Badin Business Park LLC

May 24, 2024

RE: Response to Request for Additional Information - Treatment Pilot Study
Badin Business Park, LLC

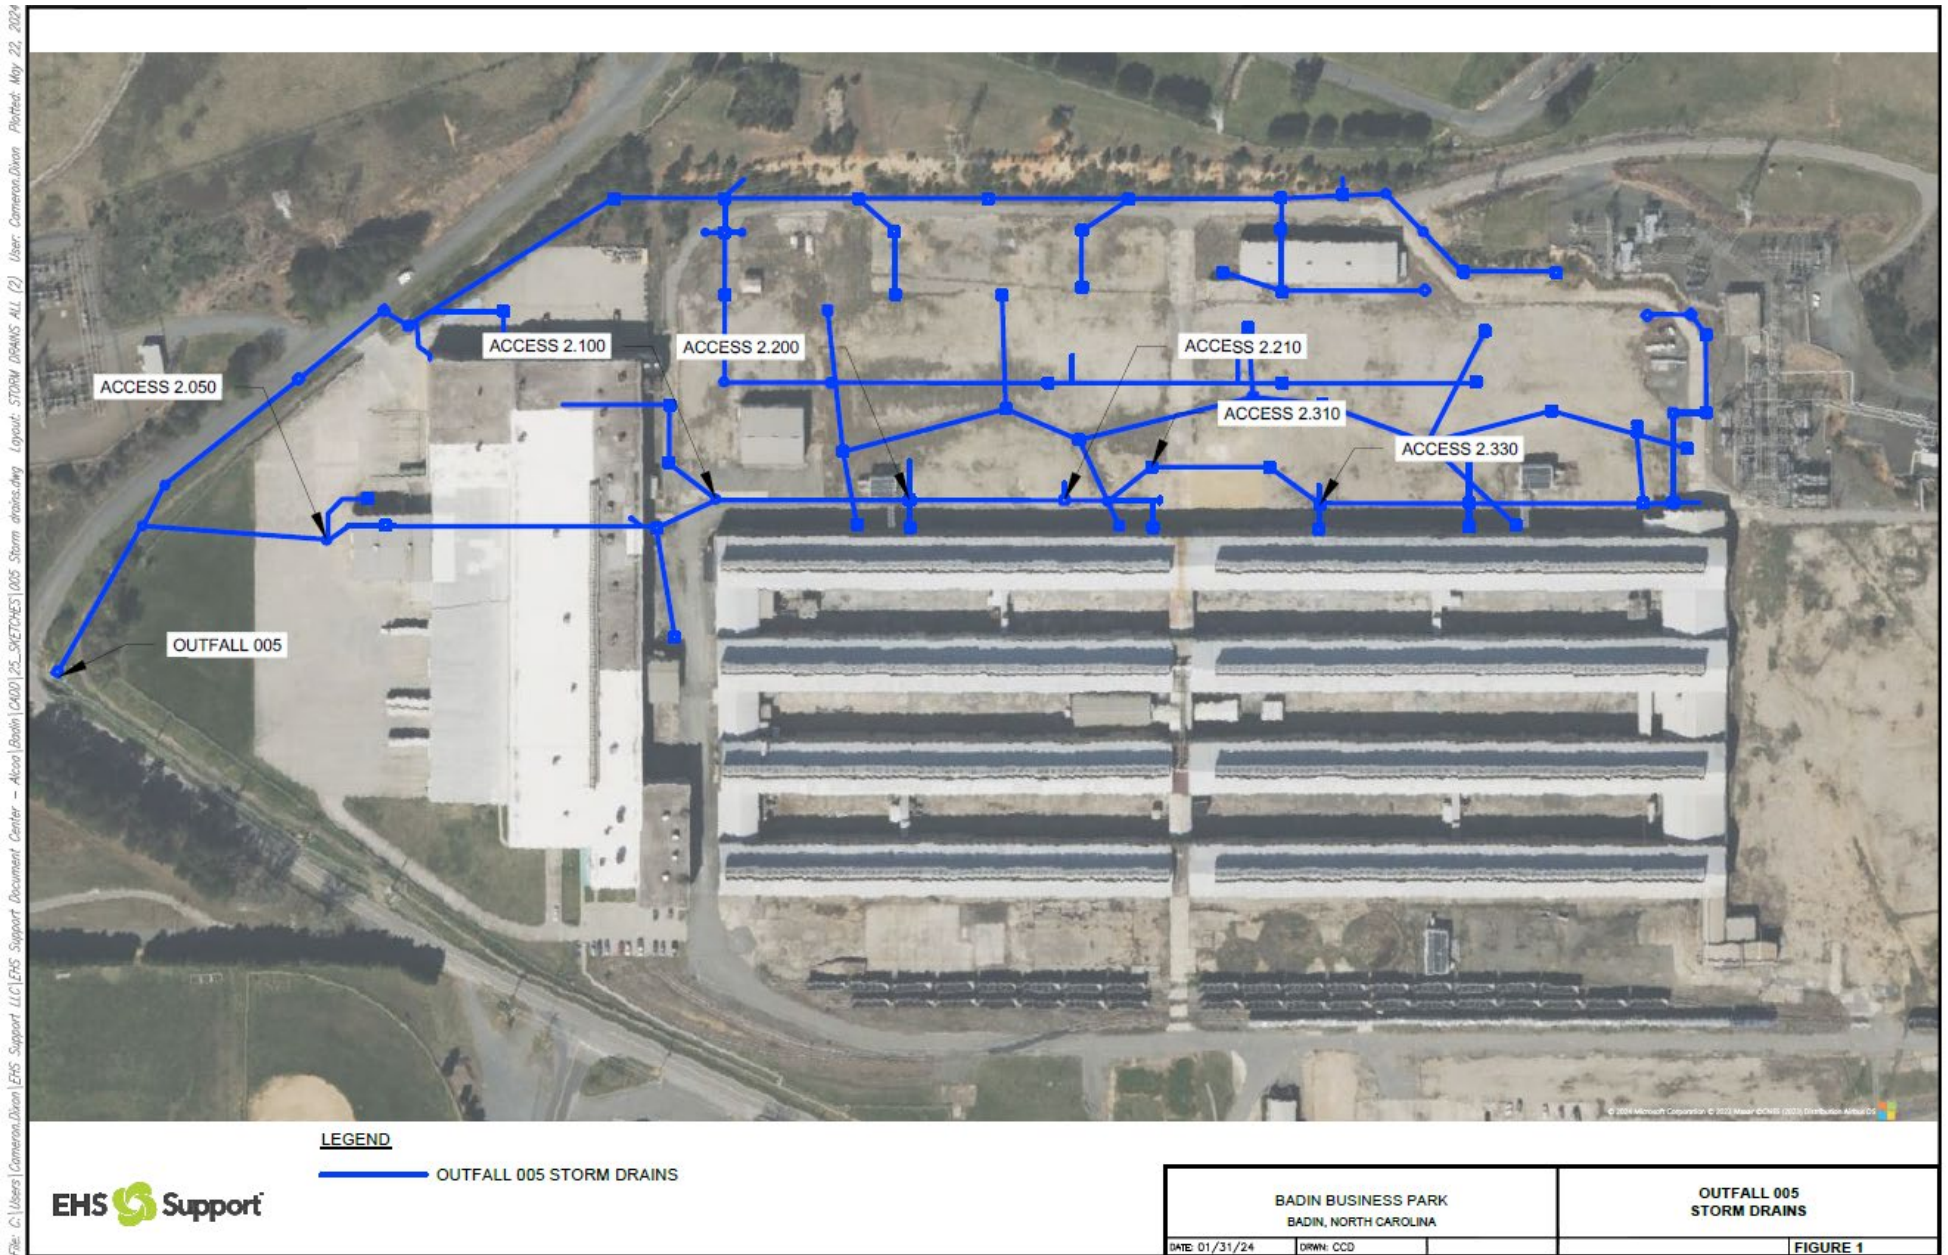
Request 1 – Include a description of the treatment system installed, including its location(s) within the conveyance.

The ex-situ system presently extracts stormwater from storm sewer utility access number 2.200 via a solar-powered, surface-mounted pump with an operating range between 3 and 18 gallons per minute (gpm). Water is being pumped directly from the storm sewer while awaiting the construction of two pumping sumps within the storm sewer near access 2.100. A delay in the sump construction was due to qualified contractor scheduling constraints. The extracted water is processed through a baffled four-chamber filter box, approximately 4 ft wide x 8 ft long x 3.5 ft deep. Each chamber is loaded with approximately 2 ft of activated alumina. The system effluent is discharged to sewer access number 2.100.
